BCA ASSESSMENT REPORT

**Oakdale West Estate, Kemps Creek
Building 2C & 2D**

**Prepared For:
Goodman Property Services Pty Ltd**

Date: 12 November 2020

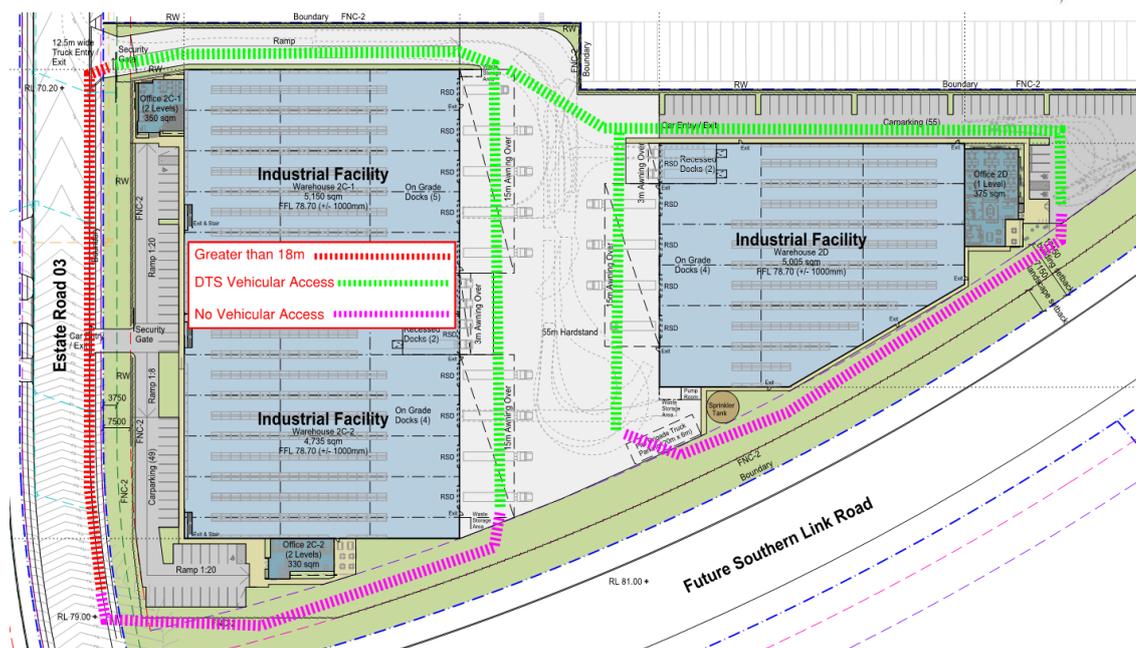
Comments: The proposed buildings do not comply with the provisions of C2.4 and thus the following non-compliance areas are identified on the site plan (over page) that are required to be addressed as an Performance Solution by the Fire Safety Engineer for each building, as follows:

- Perimeter Vehicular Access is greater than 18m from the external western wall of Building 2C.
- Perimeter Vehicular Access is not provided to the south of each building (three-sided access only).

Note 1: The driveways providing vehicular perimeter access must be designed with adequate loading capacities to withstand a fire truck and the gradients of the ramps should take into consideration to the FRNSW Policy 4 Vehicular Access Guideline.

Note 2: If the perimeter access paths are reduced to less than 6m in width to accommodate pedestrian egress paths per Clause D1.10 below, this will need to be documented in the Performance Solution.
